Date: April 27, 2004
Refer to: ER2004-0225

SUBJECT: RESPONSE TO YOUR NOTICE OF DEFICIENCY (NOD) FOR THE COMPLETION REPORT FOR THE VOLUNTARY CORRECTIVE ACTION AT SOLID WASTE MANAGEMENT UNITS (SWMUs) 0-030(I), 0-033(a), AND 0-030(a) AND AOCs 0-004, 0-010(b), 0-033(b), AND 0-029(a,b,c).

**Response to Notice of Deficiency on the Completion Report for the Voluntary Corrective Action at
SWMUs 0-030(a), 0-030(b)-00, and 0-033(a), and AOCs 0-029(a,b,c), and 0-010(a,b), and for the
Interim Action at SWMU 21-021-99
Los Alamos National Laboratory, EPA ID# NM0890010515**

Figure 4.3-2. AOC 0-029(b) previous investigation sample locations

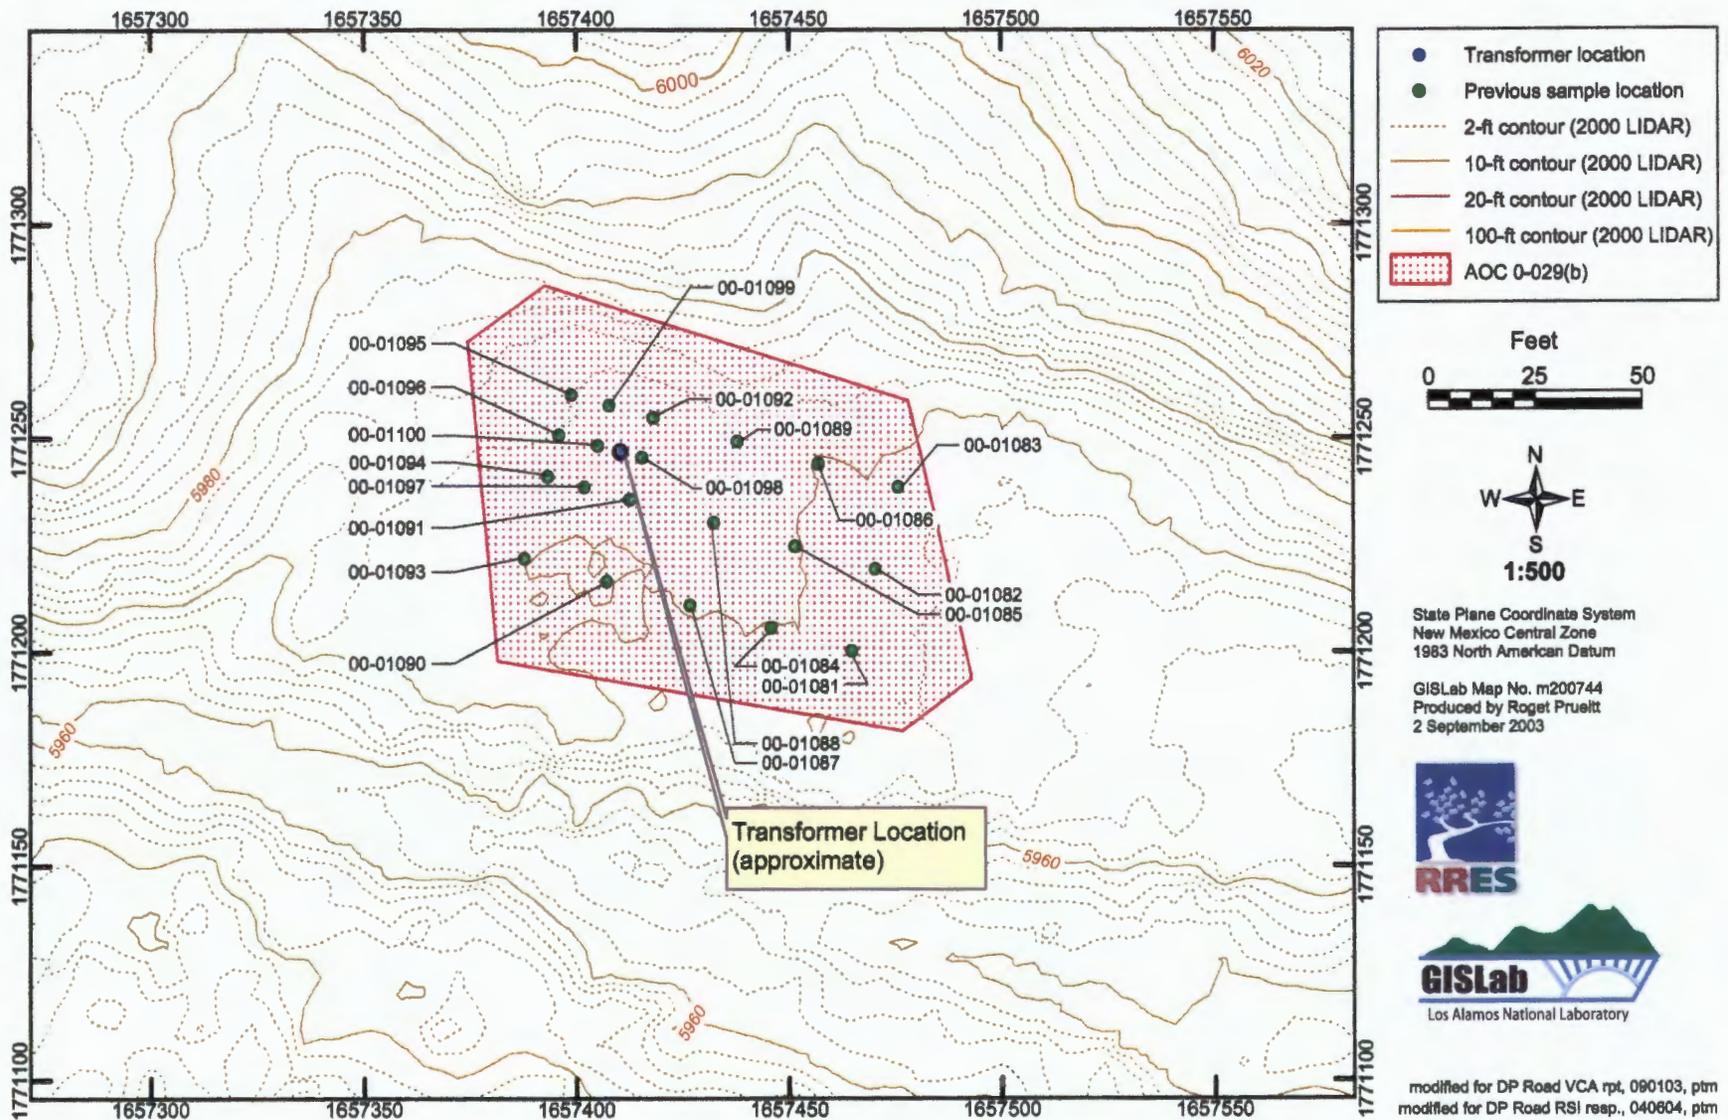
In addition, NMED cannot assess the data as it is currently presented. The two sample location maps in the document (Figure 4.3-2: previous investigation sample locations and Figure 4.4-2: RFI and VCA sample locations) do not match. Neither the coordinates of the AOC nor the shape of the AOC are the same on the two figures. The Permittees must provide maps with accurate sample collection locations to NMED. The Permittees must provide the coordinates of the sample locations and the structure locations (pump house and transformer). NMED cannot determine from the information presented in the report whether samples were collected in the proper locations.

Coordinates on Figure 4.3-2 have been corrected. The shape of the AOC in the two figures reflects the sample locations shown. Figure 4.3-2 shows the previously collected samples, while the shape of Figure 4.4-2 has been revised to show all sample locations. It should be noted that Figure 4.4-2 correctly shows both the recent sample locations and those shown (incorrectly) in Figure 4.3-2. Precise coordinates for the transformer location cannot be provided because it was not surveyed in 1992, and the pole was not present in 2002. A revised Figure 4.3-2 is included as Attachment 3.

Figure 4.3-3. AOC 0-029(c) previous investigation sample locations

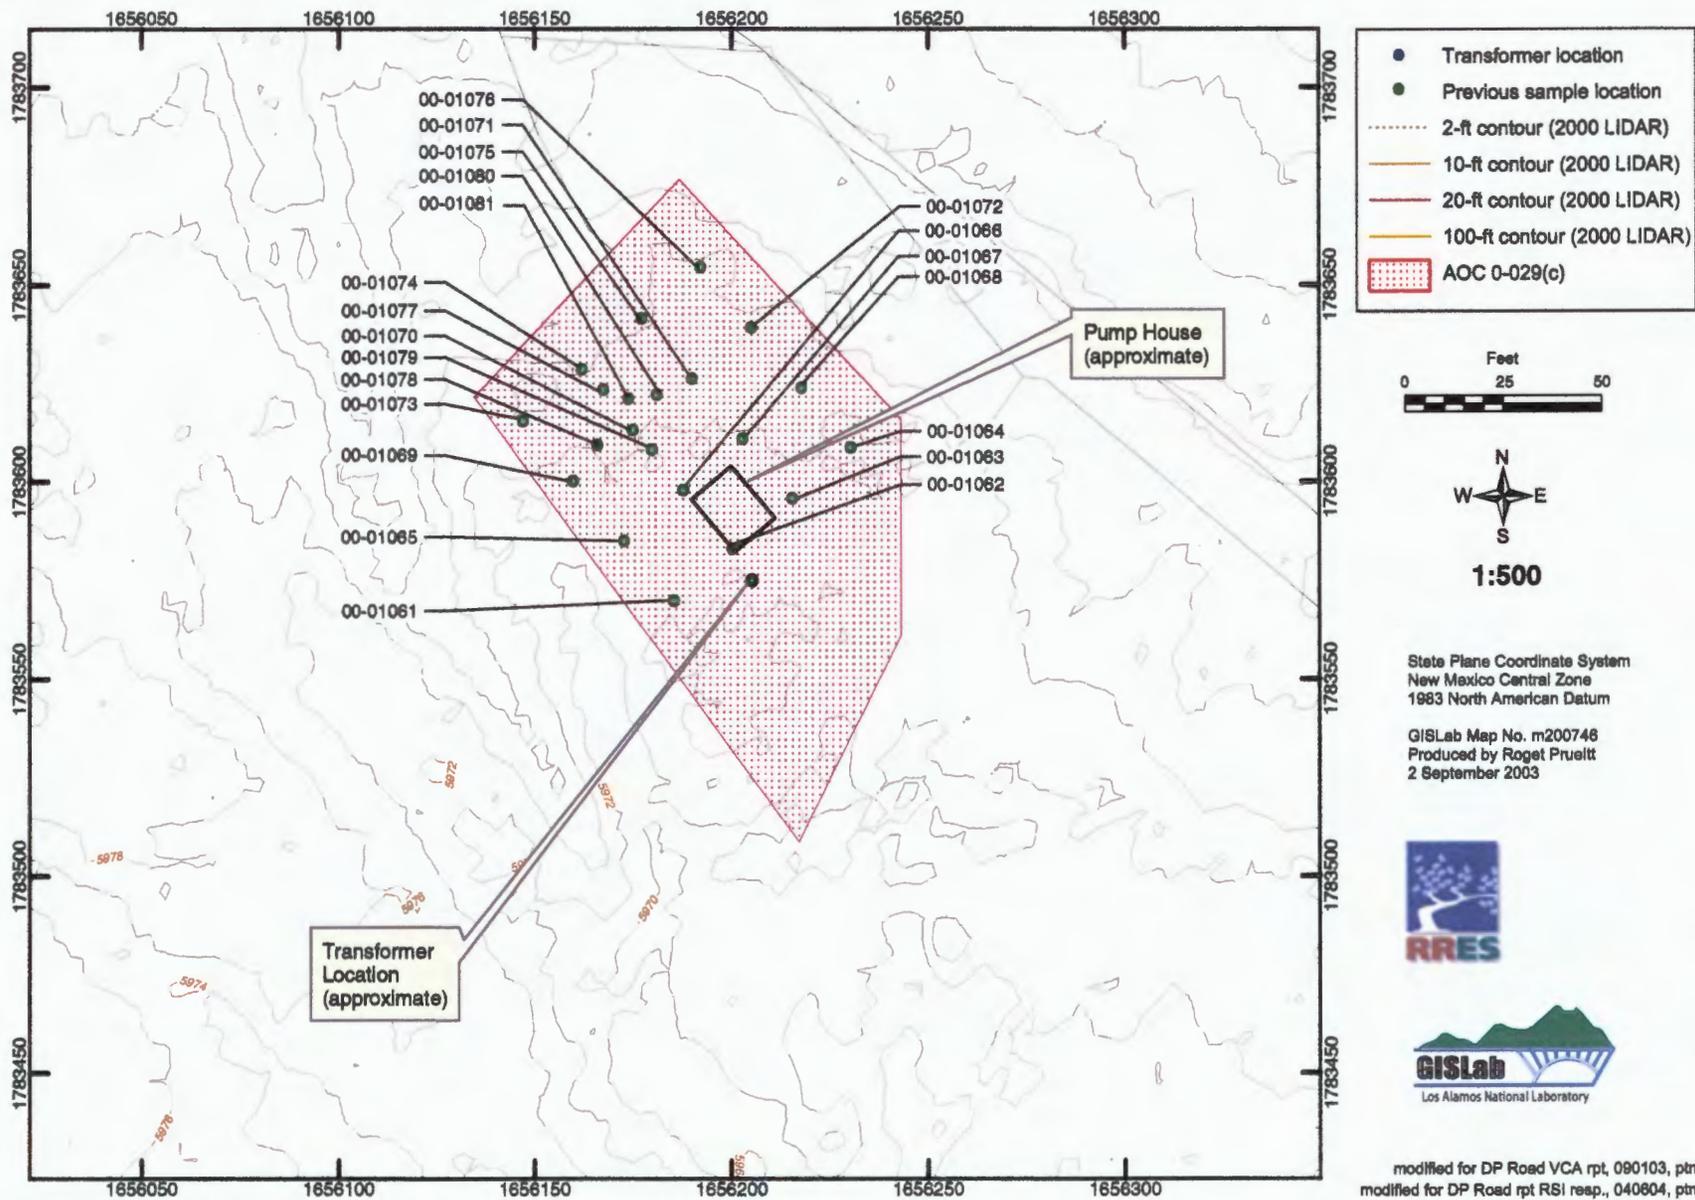
In addition, NMED cannot assess the data as it is currently presented. The two sample location maps in the document (Figure 4.3-3: previous investigation sample locations and Figure 4.4-3: RFI and VCA sample locations) do not match. Neither the coordinates of the AOC nor the shape of the AOC are the same on the two figures. The transformer is not located in the same place in relation to the pump house on the two figures. In Figure 4.3-3, the transformer is located northwest of the pump house, but in Figure 4.4-3 the transformer is located south of the pump house. The Permittees must provide maps with accurate sample collection locations to NMED. The Permittees must provide the coordinates of the sample locations and the structure locations (pump house and transformer). NMED cannot determine from the information presented in the report whether samples were collected in the proper locations.

Figure 4.3-3 is based on incorrect coordinates that were later corrected and included in Figure 4.4-3. Figure 4.3-3 will be corrected. Figure 4.4-3 is correct as provided, and includes all sample locations and the correct (approximate) locations of the pump house and transformer. Precise coordinates for the pump house and transformer locations cannot be provided because they were not surveyed in 1992, and the structures were not present in 2002. A revised Figure 4.3-3 is included as Attachment 4.
